RADIO CORPORATION OF NEW ZEALAND LTD

SERVICE SUPPLEMENT.

MODEL 052

5 Valve Dual Wave Receiver

DESIGN LAB	MODEL 052	5 VALVE DUAL-WAVE RECEIVER.	AMENDMENTS	CHKD	DATE
DRAWN <i>fw</i>	D.NO. 324				
CHECKED <i>fw</i>		RADIO CORPORATION OF NEW ZEALAND LTD.			
DATE 11-4-40

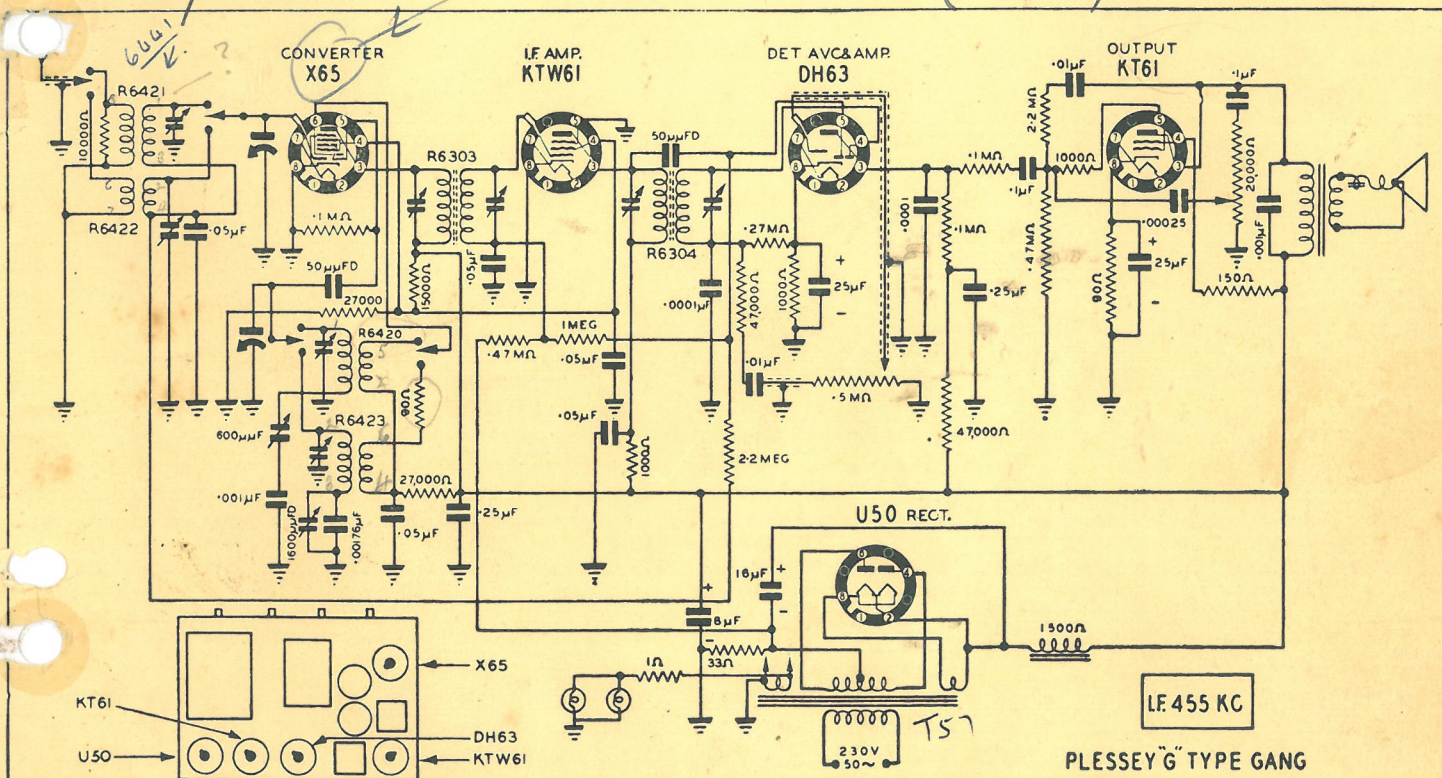
note if X65 tube is not available for a replacement use 6J8g but not a 6K8g. insert 90Ω 1/3W resistor between osc. plate and coil.
